# Submissions Report

SSD-75408008

44-52 Anderson Street, Chatswood

BRIDGESTONE PROJECTS PTY LTD

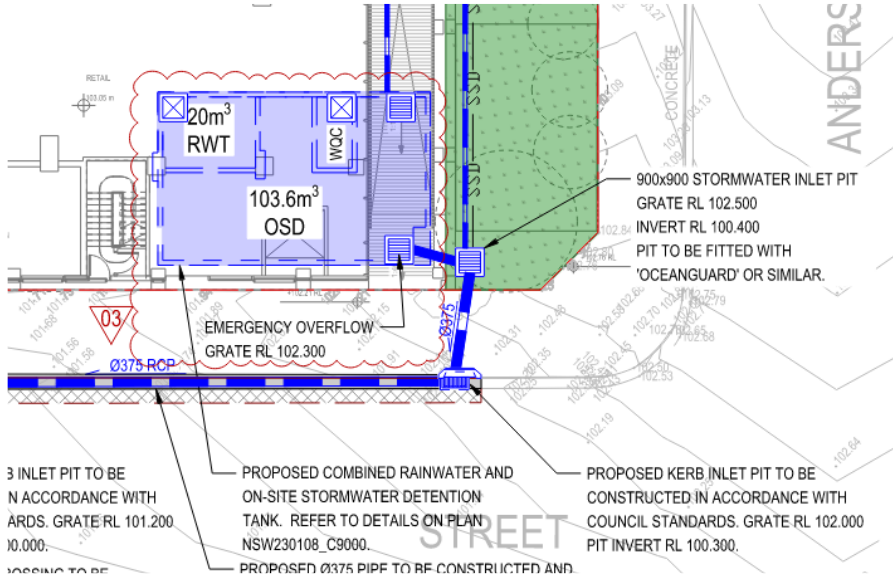
WCC-23	<ul style="list-style-type: none"> <li>- Street trees: <ul style="list-style-type: none"> <li>o Two of the street trees in O'Brien Street (T2 &amp; T3) are dead or significantly damaged and should be replaced.</li> <li>o Street tree species specified by Streetscape team: <ul style="list-style-type: none"> <li>▪ Anderson Street frontage: 5 x 200L Fraxinus 'Raywoodi'</li> <li>▪ O'Brien Street frontage: 3 x 200L Pyrus callieriana</li> <li>▪ The existing trees on Day Street are to be retained and protected</li> </ul> </li> </ul> </li> </ul>	<p>Trees on Day Street are not subject to removal.</p> <p>Street tree selection will be made in accordance with Council's request, as follows:</p> <ul style="list-style-type: none"> <li>• Anderson Street frontage: 5 x 200L Fraxinus 'Raywoodi'</li> <li>• O'Brien Street frontage: 3 x 200L Pyrus callieriana</li> </ul>
WCC-24	<p><b>BASIX landscape requirements</b></p> <ul style="list-style-type: none"> <li>- The BASIX certificate shows a requirement for 250m<sup>2</sup> of indigenous, low water use planting in common area landscape. The area of landscaping to comply with this requirement is not indicated on the plans</li> <li>- The 250m<sup>2</sup> is to be clearly indicated on the landscape plans.</li> </ul>	<p>The planting schedule in the Landscape Design Report at <b>Appendix M</b> identifies the proportion of native species proposed, which, although not easily illustrated on the plan due to the integration of native and exotic species, ensures it is in exceedance of the required 250m<sup>2</sup> of native planting area.</p>

### c) Engineering Comments

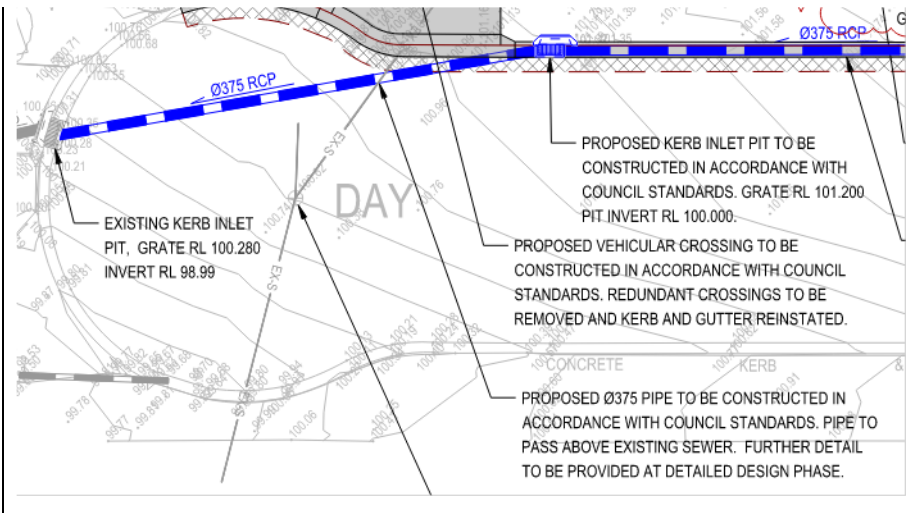
WCC-25	<p><b>Traffic and further parking issues</b></p> <p>The swept paths for the loading bay and access to the loading bay detail that access is for an MRV. This size</p>	<p>All swept paths for the loading bay have been conducted using a 10.5m long vehicle – consistent with the size of Council's waste collection truck. The design includes a 2m zone at the rear of the vehicle to allow for</p>
--------	---	---

vehicle is smaller than Council's 10.5m waste vehicle. As Council needs to be able to collect waste from residential units, the loading bay and access to it must be designed to cater for Council's 10.5m waste vehicle, with 4.5m headroom.	loading / unloading of goods – in accordance with Council's requirements. The design provides for 4.5m height clearance in the loading area.
WCC-26	The plans and Traffic Report do not address vehicle/pedestrian conflict in the shared loading bay zone, which is unsuitable for service vehicle manoeuvring, especially reversing.	The loading bay area is not shared with pedestrians and is intended for the sole use of service vehicles. Pedestrians exiting the lifts at basement 1 level will not be required to cross the loading bays to access the car park at this level. The loading bays will be clearly line-marked and signposted to communicate to building occupants that this is for the use of vehicles only.
